# RCRBD Record Set

FOUNDATION		
BARN/BUNKHOUSE LONESOME BEAR RANCH ROKITA COUNTY, COLORADO		
	<b>Bear Valley Design, Ltd.</b>	
	Engineers - Consultants	
P. O. BOX 475 STEAMBOAT SPRINGS, COLO. 80477 (870) 878-5454		
DATE: <u>SEP 11/80</u>	SCALE: <u>AS NOTED</u>	JOB: <u>—</u>
DRWN: <u>CHK.</u>	APP: <u>[Signature]</u>	REV: <u>0</u>
SHEET <u>15 OF 39-D</u>

**SHEET 2 OF 36-D**

Subject: Soil investigation and LTAR evaluation for a two buildings and an Onsite Wastewater Treatment System (OWTS) on a 100.94 acre tract of land on the Lonesome Bear Ranch in T5N R868W, in Routt County, Colorado.

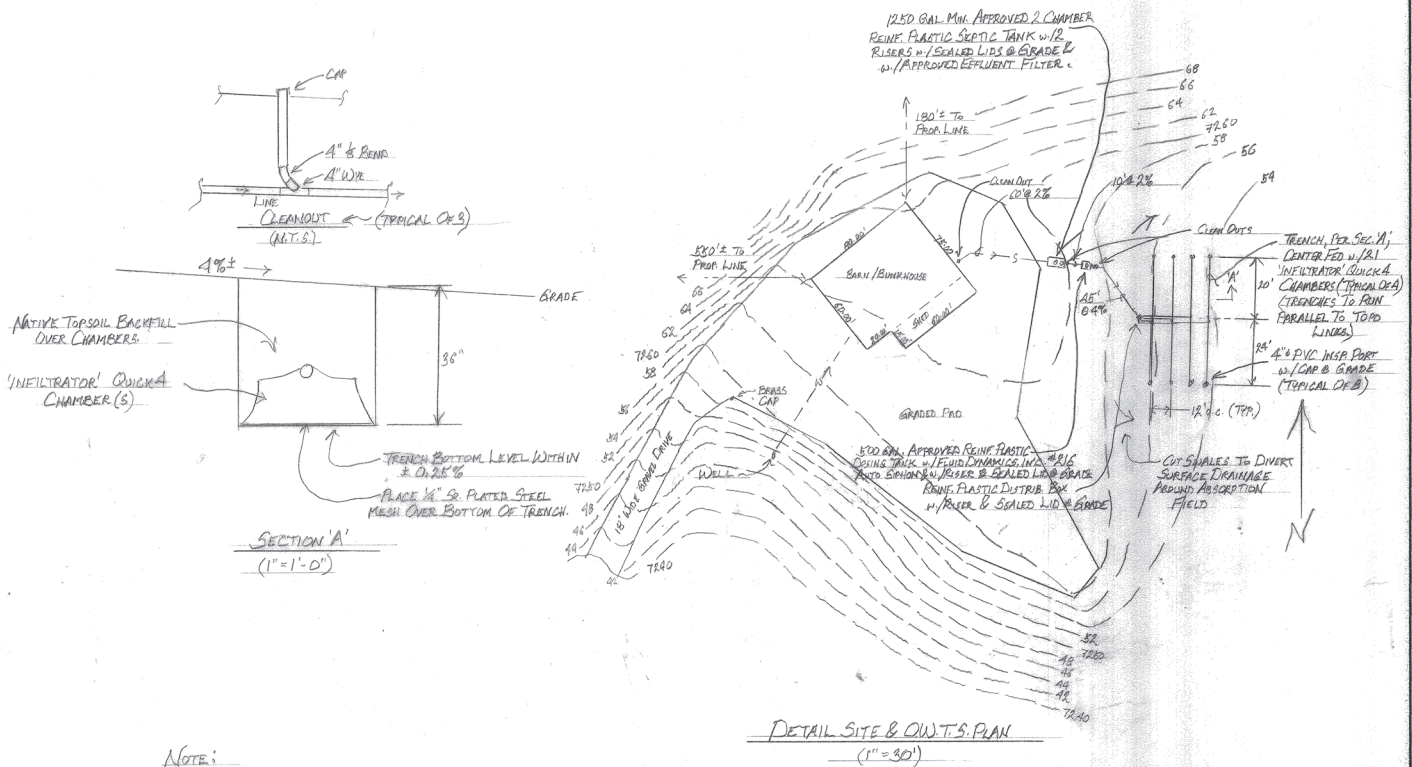
Meter Location will be determined after on site visit with YVEA Craig Field Representative. Meter & meter pedestal are to be located as described by YVEA. They shall not be enclosed, covered or concealed Violation shall result in termination of service.

Yampa Valley Electric Assn. INC  
This Approval addresses only  
the meter and service location  
Approved: Scott Flowers - YVEA 10/01/19

**FOUNDATION**

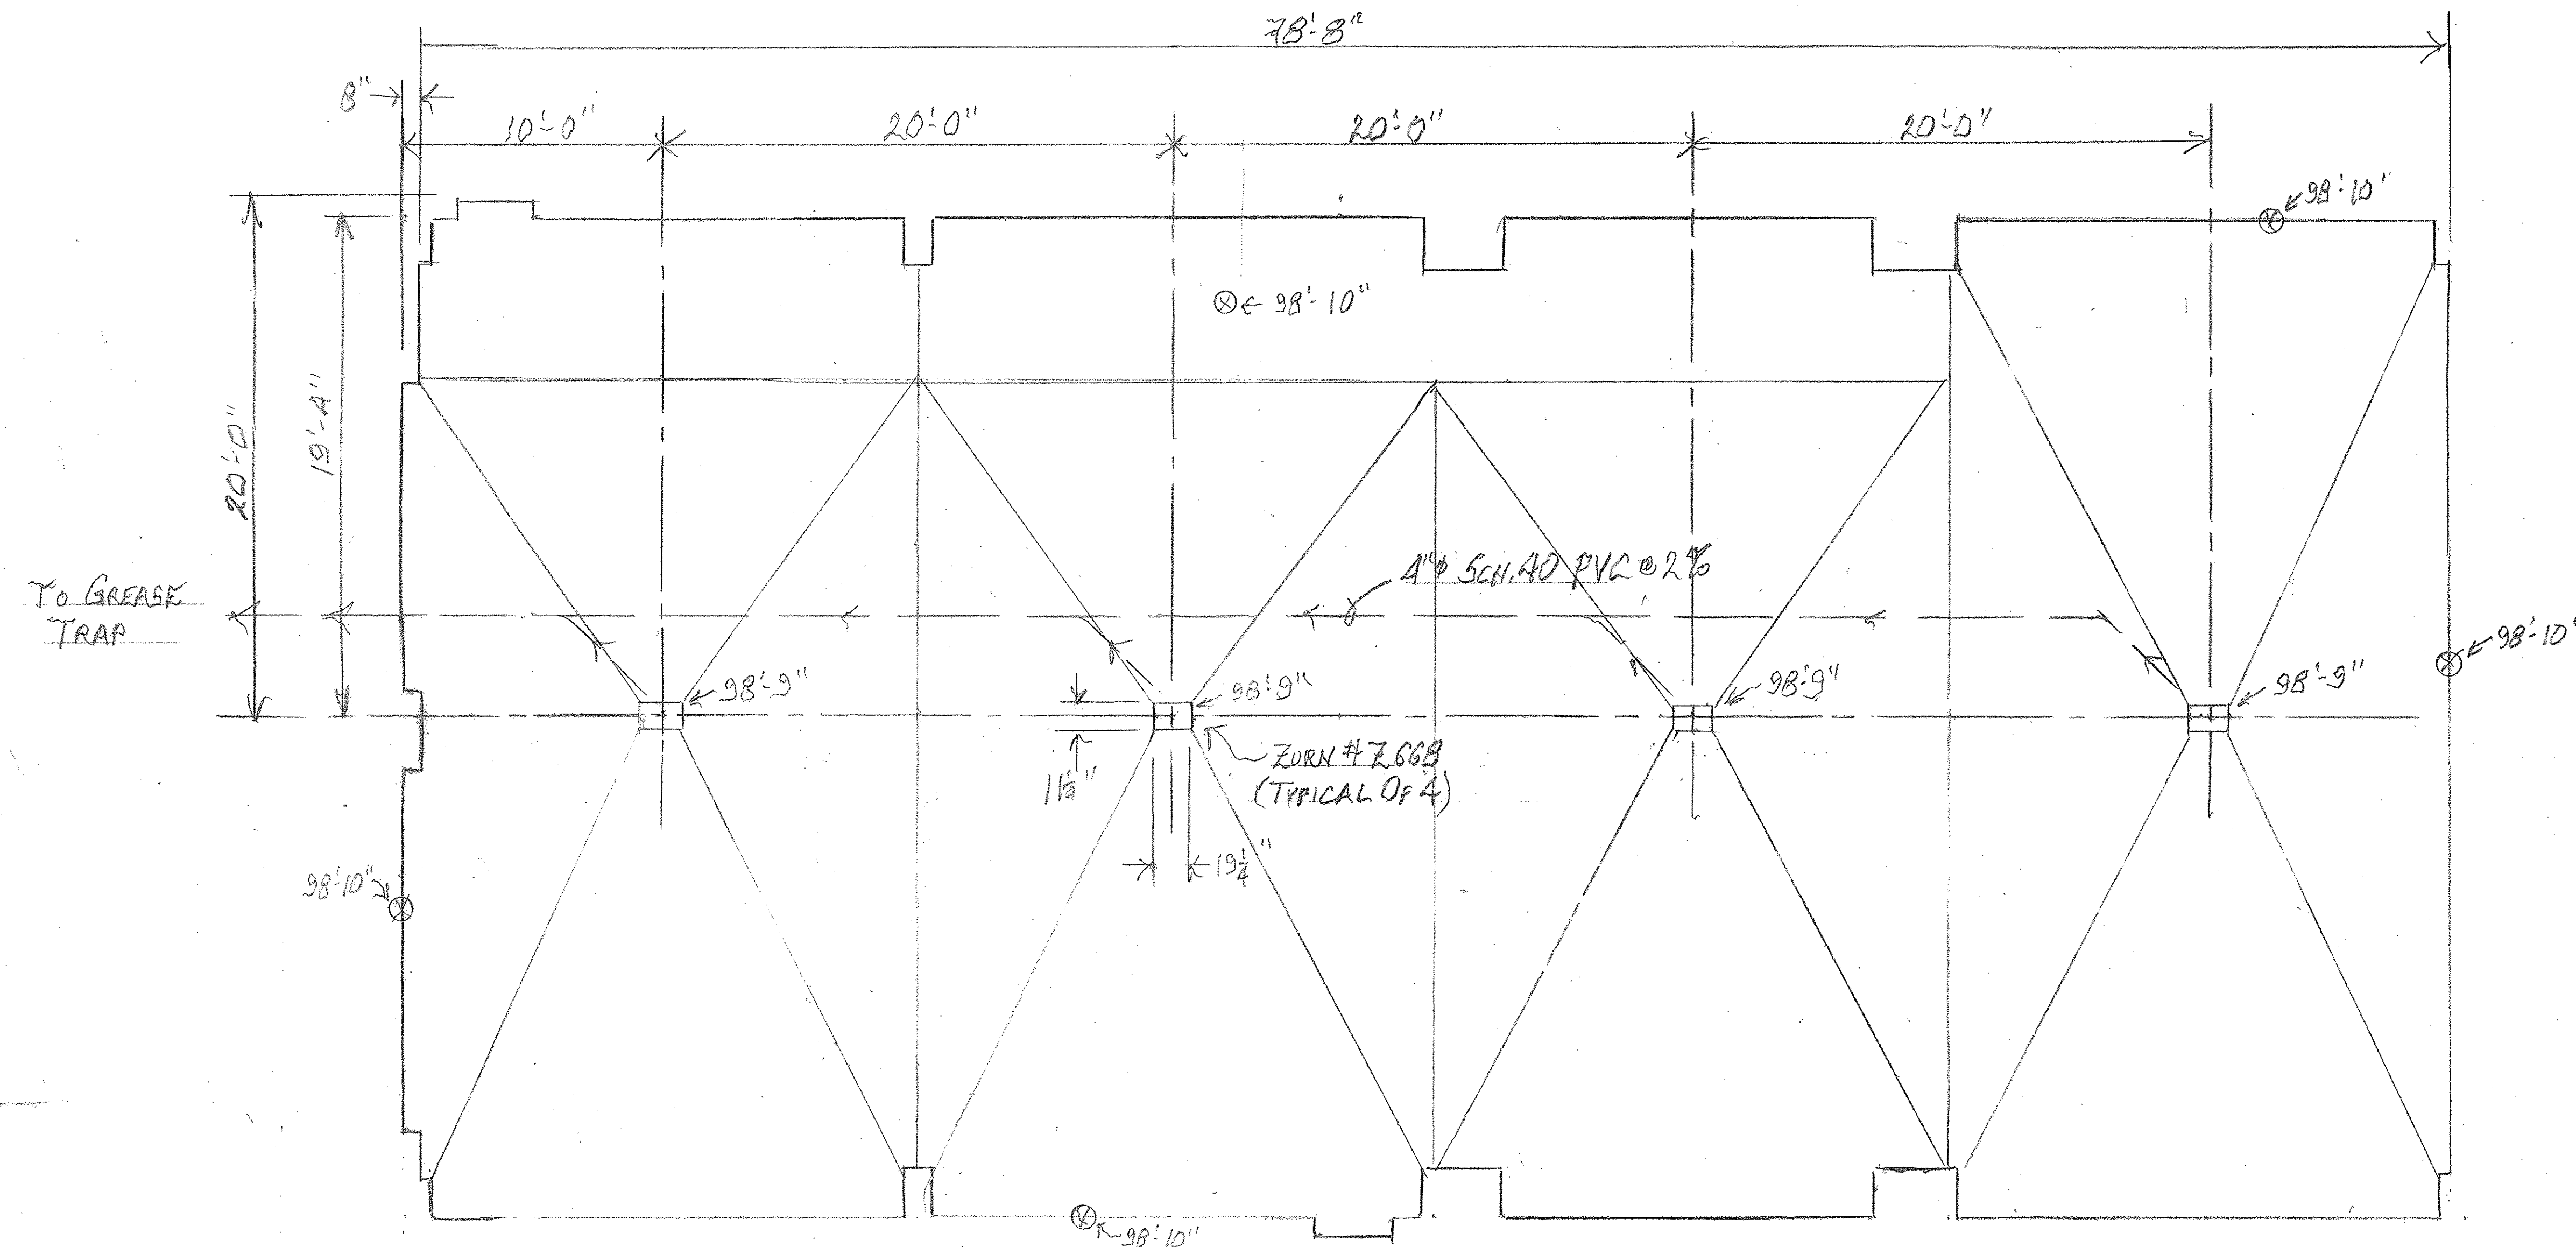
At the present time, Mike and I are discussing alternative methods for dealing with the insulation gap you pointed out where the rock veneer (which is not extend more than 4" above grade) extends below grade. We will have this detail worked out before it is time to pour the floor slab.

Yes, the slab on the main floor will incorporate hydronic radiant heating, and insulation under the slab, between the 'Barrier' vapor barrier I specified on the drawing and the foam material (with buttons for locating the tubing) with have an R value of at least R5.

The anchor bolts will be as follows:

3/4" D., imbedded in the pilasters (5 locations on each side) will be 36" long with a 4" right angle hook at the bottom and 5" length of 3/4" D. UNC thread at the top.

3/4" D. imbedded in the end walls for end wall columns will be 18" long with a 3" right angle hook at the bottom and 5" length of 3/4" D. UNC thread at the top.

All 1/2" D. bolts for miscellaneous door frame attachments may be typically available commercial drill in type cinch anchors.

All 3/4" bolt shall be either of A-36 steel or meet the building manufacturer's noted 'F1554' spec, whichever is more stringent.
